## 2020-07 BAR Decision for 422 1st Street North

### **Certificate of Appropriateness Application**

BAR 20-07-07

Addition to residence

A2.0

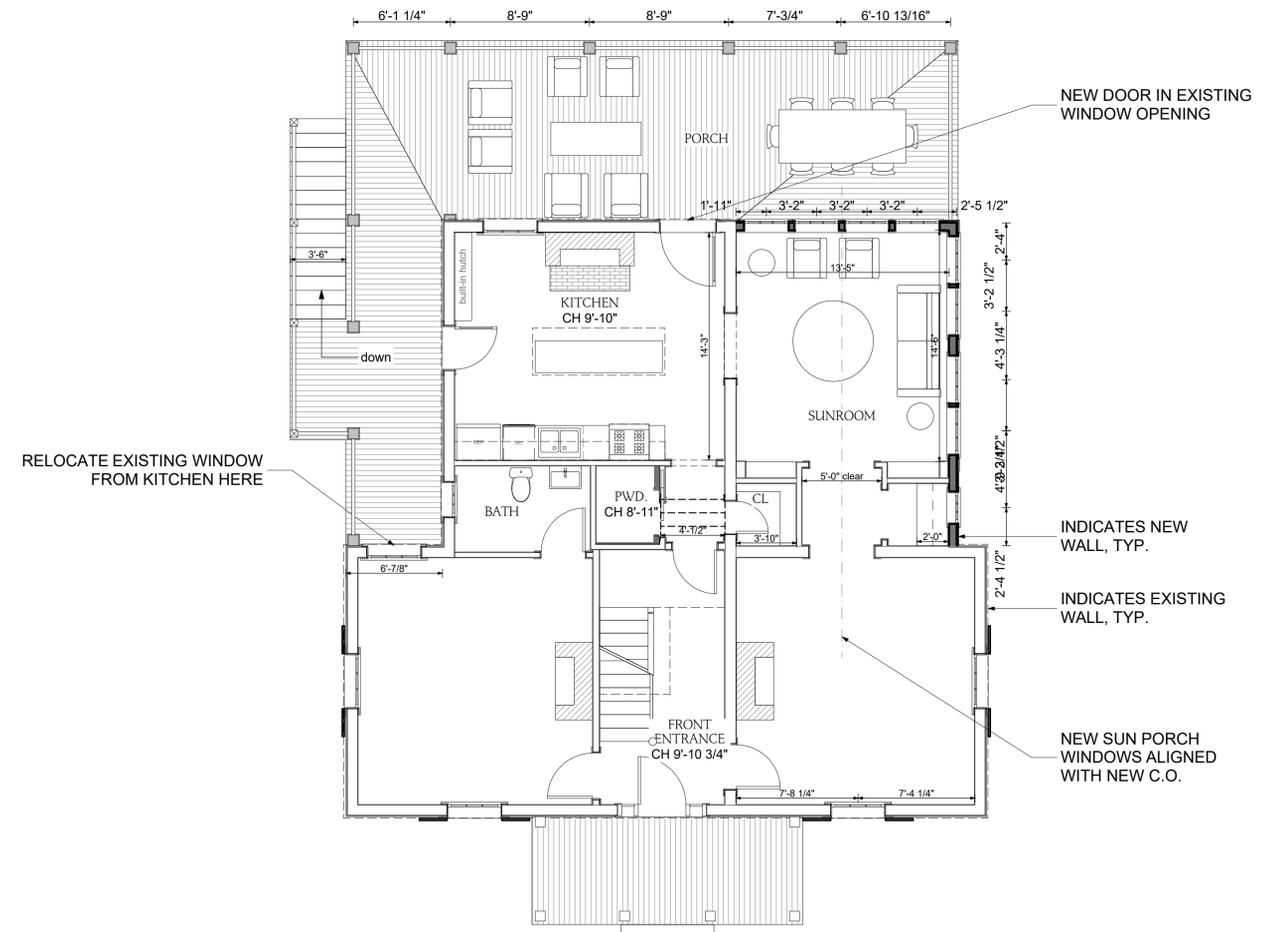
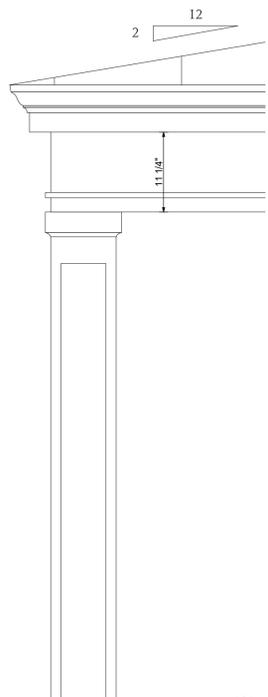
- The siding exposure and profile
- The proposed lighting
- The new shutters
- The roof peak and chimney location
- Upper roof material

BAR should discuss the relocated chimney. No details are provided on the materiality.
